From: PUBCOMMENT-OCC
Sent: Wednesday, February 12, 2025 5:28 PM
To: PUBCOMMENT-OCC2; PUBCOMMENT-OPIC; PUBCOMMENT-ELD; PUBCOMMENT-WQ
Subject: FW: Public comment on Permit Number WQ0016373001

REGULATED ENTY NAME HAYS COMMONS WASTEWATER TREATMENT PLANT

Re: TCEQ Permit Application No. WRPERM WQ0016373001, Hays Commons Wastewater Treatment Plant for Hays Commons Development Inc.

Analysis of Irrigation Areas Near Critical Environmental Features

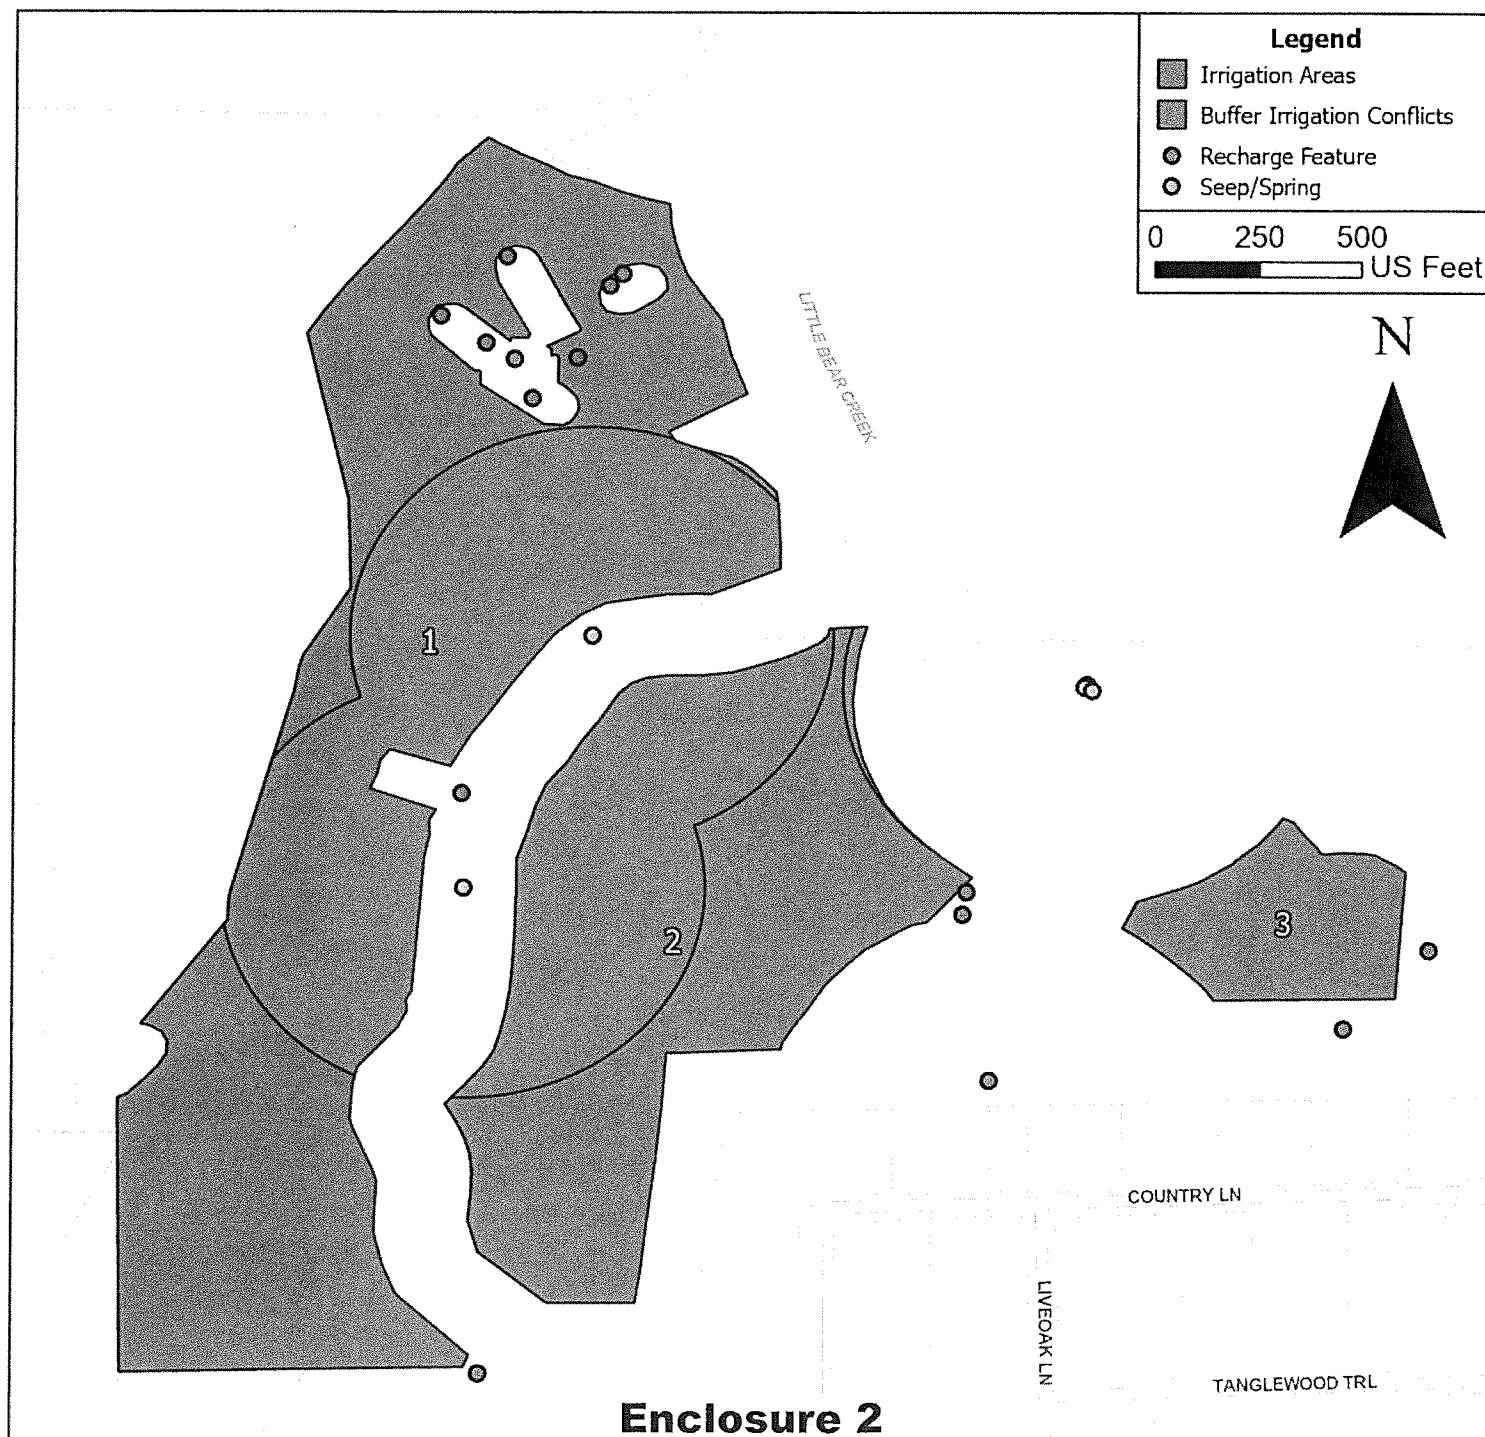
Comment: Karst recharge features have been identified within the proposed irrigation area. The City of Austin typically requires a 150-ft buffer around karst critical environmental features. Given the proximity of the irrigation area to both the City of Austin Extraterritorial Jurisdiction and WQPL lands, a more substantial buffer around recharge features would be appropriate.

Irrigation Zone	Area (Acres)	Conflict Area (Acres)	Percent
1	35.93	17.53	42.19
2	19.68	10.19	44.78
3	3.91	0	0

- Provide the 500-ft buffer required by the permit around all springs/seeps identified in the Environmental Assessment.
- Add special provision that the permittee shall provide an emergency storage pond for the volume of plant to contain the capacity of the wastewater treatment plant in the event of plant failure and to prevent complete purging of the treatment system into localized karst features hydrologic connected with the Edward Aquifer. The proposed location of this pond, if applicable, shall be submitted to the Water Quality Assessment Team at MC 150 prior to construction of the wastewater treatment plant. Any construction of a new pond shall comply with Special Provisions 29, 30, 31, and 32. Any new pond shall be lined in accordance with Special Provision 18.

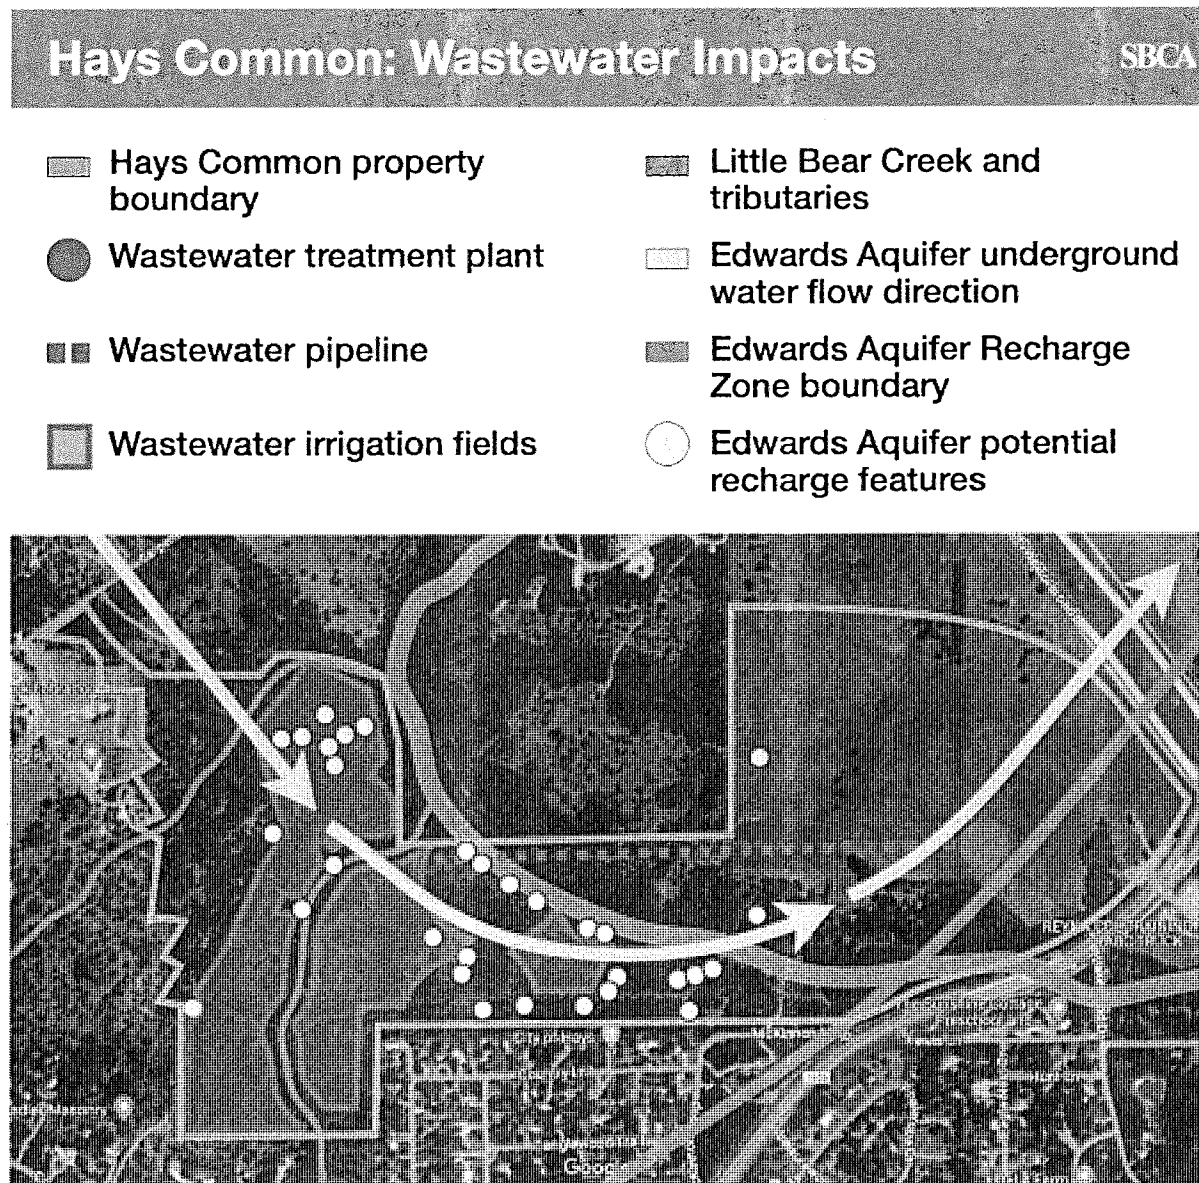
Because neither TCEQ nor the applicant have presented maps that show the interaction of Hays Commons' wastewater system with the Edwards Aquifer or with Little Bear Creek (a tributary of Onion Creek, a pristine stream), SBCA has prepared our own map, shown as Attachment A. And to further reinforce the sensitive nature of this area, we also want to show the location of Hays Common with respect to the City of Austin's Water Quality Protection Lands, shown in blue on Attachment B

In summary, the draft permit for Hays Common is inadequate to protect the Edwards Aquifer and surrounding features, and SBCA asks TCEQ to withdraw it.
